LAKEVIEW MASTER DEVELOPMENT PLAN PLAN #: DATE 04/14/05

MASTER DEVELOPMENT PLAN

MDP# 836

The City Staff Development Review Committee has reviewed Lakeview Subdivision Master Development Plan M.D.P. # 836. Please find enclosed a signed copy for your files. Your plan was accepted, however please note the following:

MDP/Map

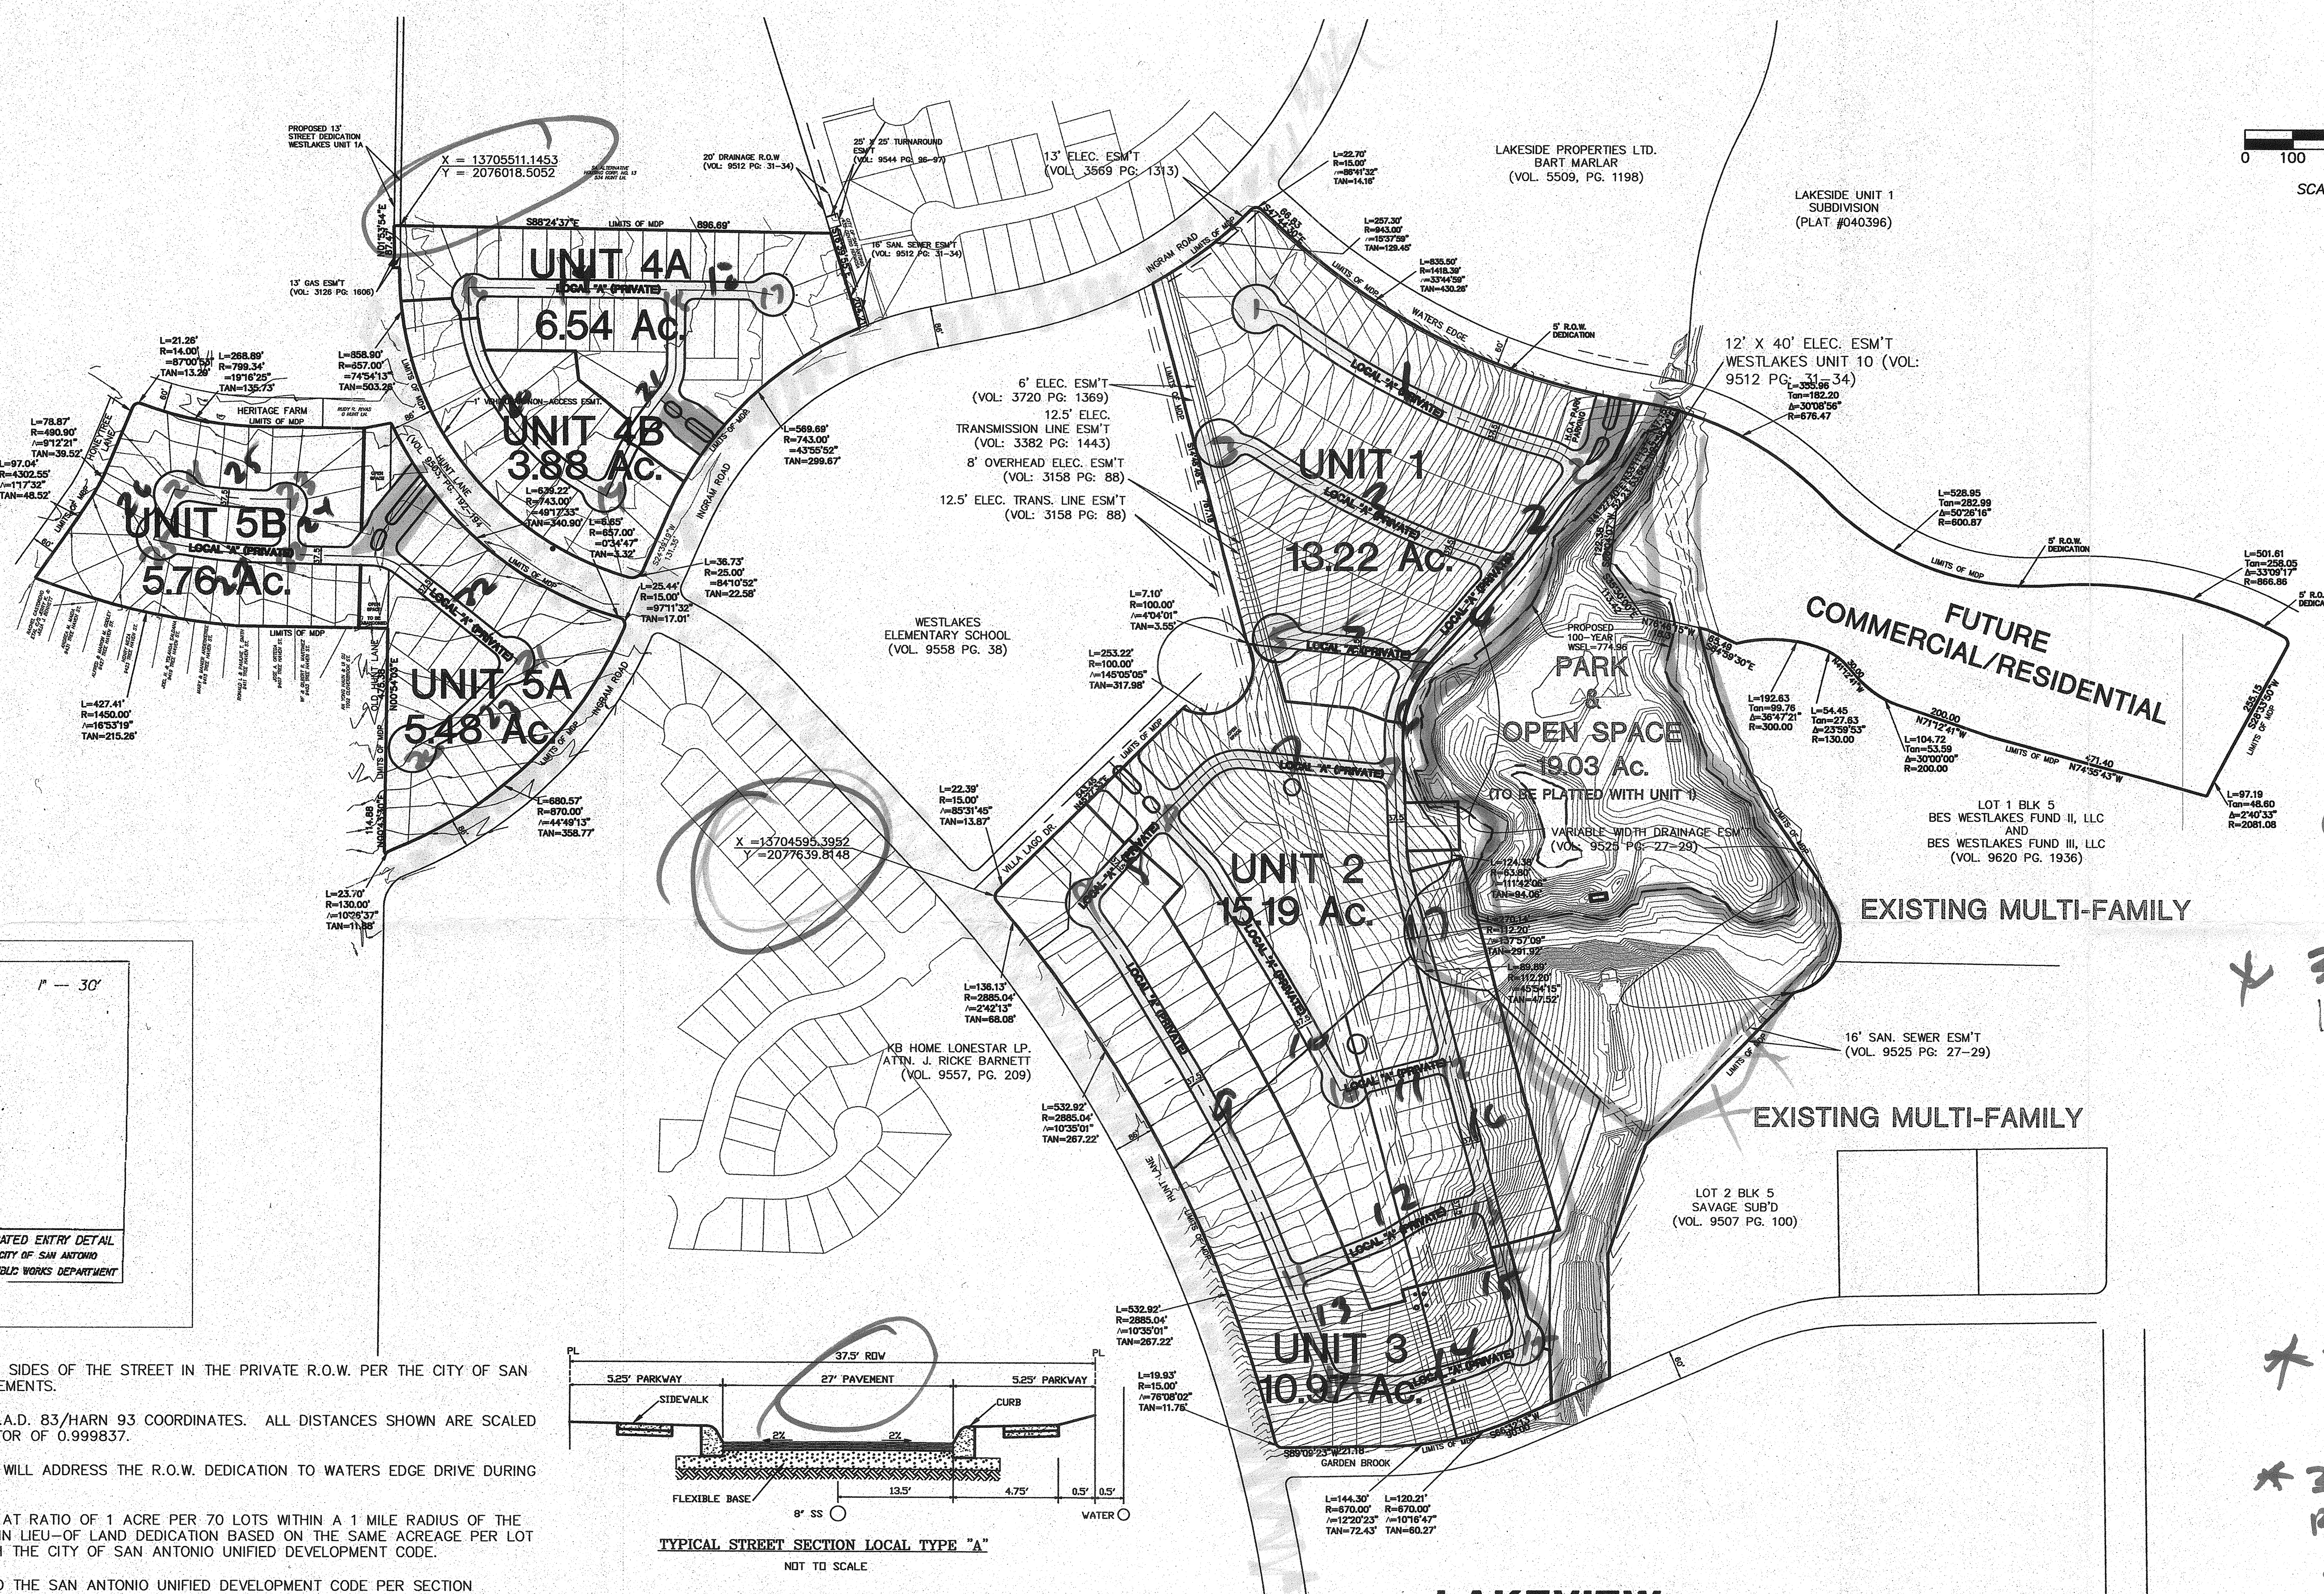
Ingram Rd does not scale to 86'. Please clarify and re-submit.

Some sections of the plan are labeled with zoning and some are not. Two of those areas labeled are labeled incorrectly. The area within 19.03 acres of proposed park and open space east of Units 1 and 2 is zoned PUD R-5, not R-6 as labeled.

The areas outside of the PUD plan to the east are labeled. The one that is labeled as R-6 is incorrect, it is actually zoned MF-33.

Please note, the majority of Unit 6 is zoned C-2 NA Commercial Nonalcoholic Sales District and cannot be developed with detached residential units as suggested in the table on the Plan.

TYPICAL STREET SECTION LOCAL TYPE "A"
NOT TO SCALE

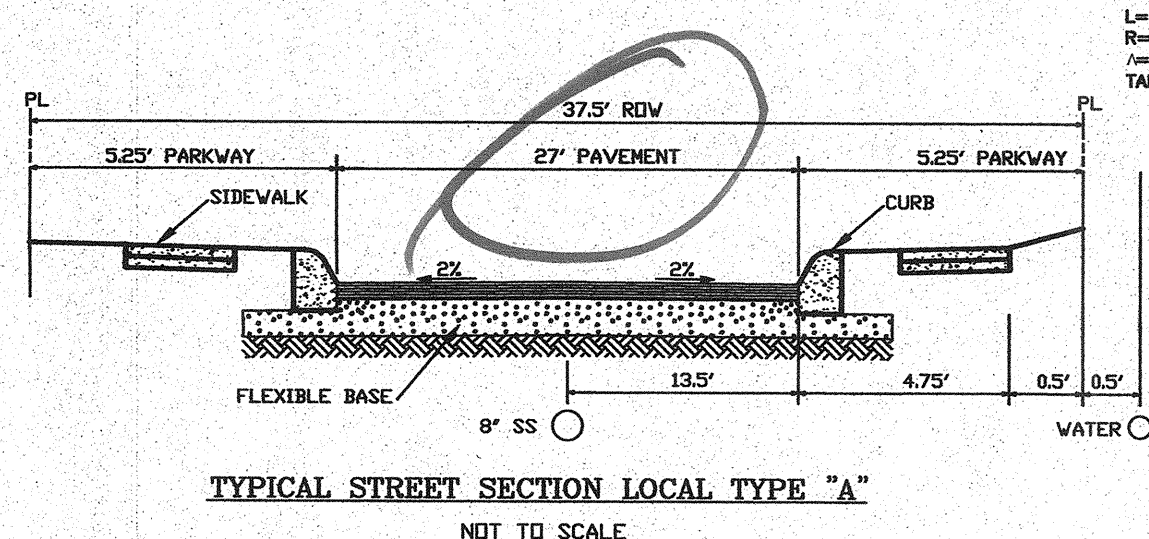
** 35-8101
Local B around tanks
* 35-506-LOCAL A
Require 50 MIN RAIL
20' pavement*

- c. The plat for Lakeview, Unit 1 shows Lot 1 as a standard lot. Therefore, note 8 should be deleted as well as the "H.O.A. Park Parking" notation.
 - d. Revise typical street section. The 9 inch curb, 2-foot minimum planting strip(not required on Local A's) and a 4-foot sidewalk will not fit in the 5.25-foot parkway.

TREE STAND DELINEATION PLAN

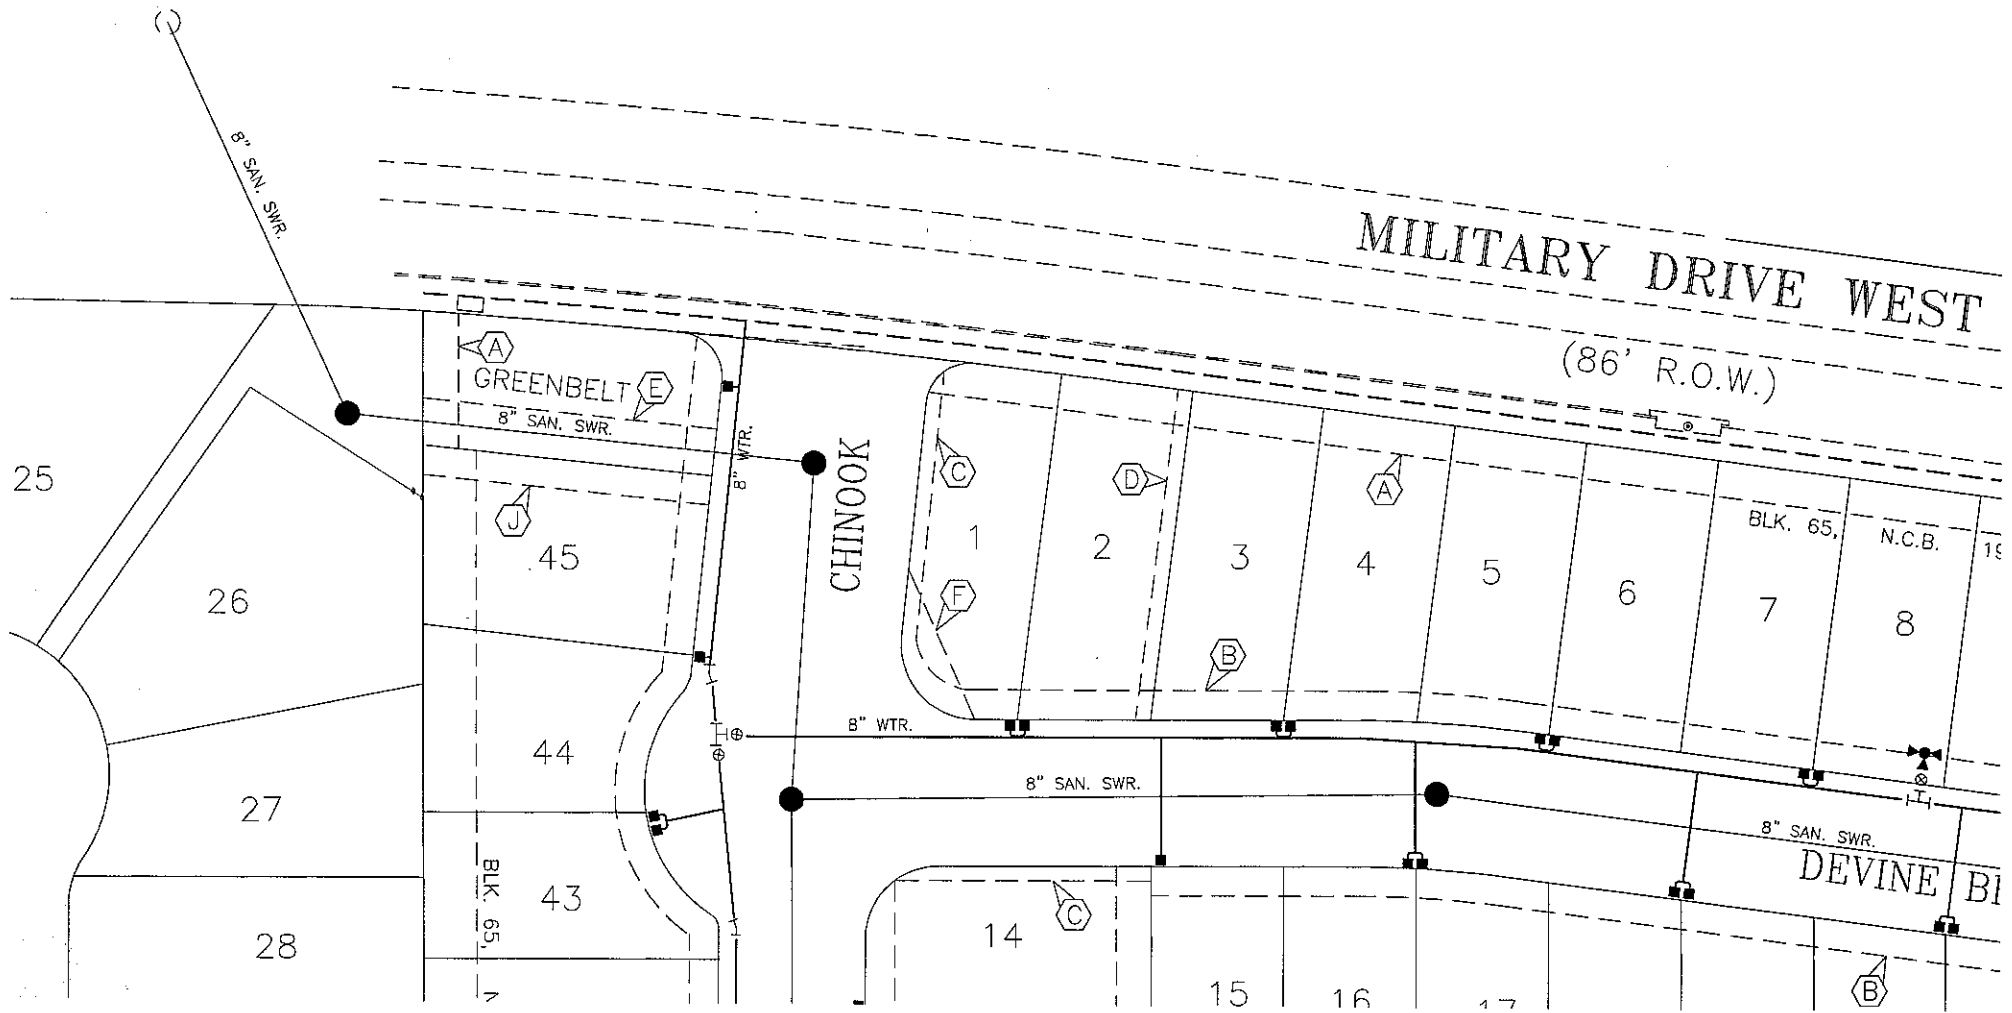
1. Plan does not meet the criteria of the 2003 Tree Preservation ordinance (Section 35-B101)
2. Master Tree Stand Delineation Plan with basic non-committal information
3. Square footage of project and of tree canopy area
4. Basic information on types of dominant trees i.e. Live oak, Cedar elm, re-growth Mesquite, Huisache, re-growth Juniper/Mountain cedar, etc. and under story vegetation i.e. Agarita, Johnson grass, etc.

- ☐ Copy of the MDP
- X Master Tree Stand Delineation Plan with basic non-committal information
- ☐ \$75 Plan Review fee
